# SYDNEY WESTERN CITY PLANNING PANEL ASSESSMENT REPORT

Panel Number:	PPSSWC-409.	
Application Number:	2024/96/1.	
Local Government Area:	Camden.	
Development:	Construction of a new registered club premises and outdoor recreation facility in conjunction with an existing golf course, including golf driving range, driving range netting, 27 hole mini golf course, lighting, car parking, drainage construction, landscaping and all associated works.	
Capital Investment Value:	\$45,195,295	
Site Address(es):	880 and 890 Camden Valley Way, Gledswood Hills.	
Applicant:	Western Suburbs League Club (Campbeltown) Limited.	
Owner(s):	Western Suburbs League Club (Campbeltown) Limited.	
Date of Lodgement:	22 March 2024.	
Number of Submissions:	Three submissions.	
Number of Unique Objections:	Two objections.	
Classification:	<ul><li>Regionally significant.</li><li>Nominated integrated development.</li></ul>	
Recommendation:	Approve with conditions.	
RegionallySignificantDevelopmentCriteria(Schedule6ofEnvironmental Planning Policy(Planning Systems) 2021):	General development capital investment value >\$30 million.

List all Documents Submitted with this Report for the Panel's Consideration:	<ul> <li

Cross section showing excavation and proposed parking layout.

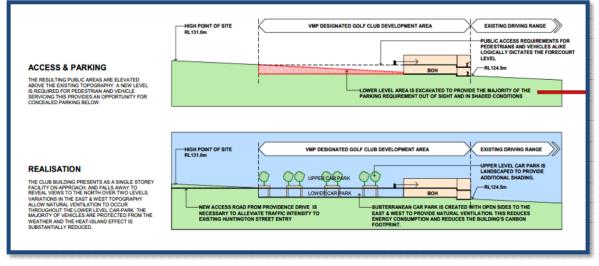
1. The Panel queried what response has been made to the Design Review Panel's suggestion that the car parking be provided underground.

As highlighted later in this report, the DA was briefed to Council's Design Review Panel (DRP) on 25 March 2024. The DRP provided various comments and recommendations regarding the proposed design of the golf club. Concerns were raised with the large expanse of car park which is visible from the entertainment area and from the residents of the future apartments planned for the site to the south. It was suggested by the DRP that that the car park should be relocated entirely underground.

The applicant has advised that the site's existing topography is undulating and it is not practical to provide all parking underground. A substantial amount of excavation is proposed to ensure the parking structure is nestled into the site to reduce the visual impact. Approximately 11,300sqm of site area is to be excavated to provide the lower-level car park and loading dock facilities which allows 58% of the parking spaces to be provided at the lower level which are visually screened. The car park is not considered to be highly visible as demonstrated in the Visual Impact Assessment submitted with the DA.

A series of amendments to the plans have been made since briefing the DRP, which have reduced the impact and improved the design of the hard stand area including a reduction of 30 car spaces and introduction of large canopy trees scattered throughout the car park. Further details on the DRP's commentary and the applicant's response are provided in the next section of this report.

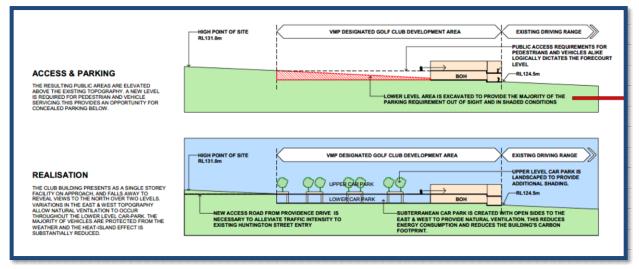
The DRP highlighted that a strong design philosophy should be established for the building. The Panel considered the format to be inwardly focused, appearing to be driven by the commercial golf driving range.

The applicant has clarified that the design philosophy of the club has been led by the need to integrate it into the landscape and directly connect the nine-hole golf course and managed vegetated lands which surround it. The design is centered around the relationship between the new uses and existing site conditions. The built form is divided into three components with a natural light filled central spine which provides connectivity to the differing uses and a central hub that provides views out toward the golf driving range and entertainment precinct.
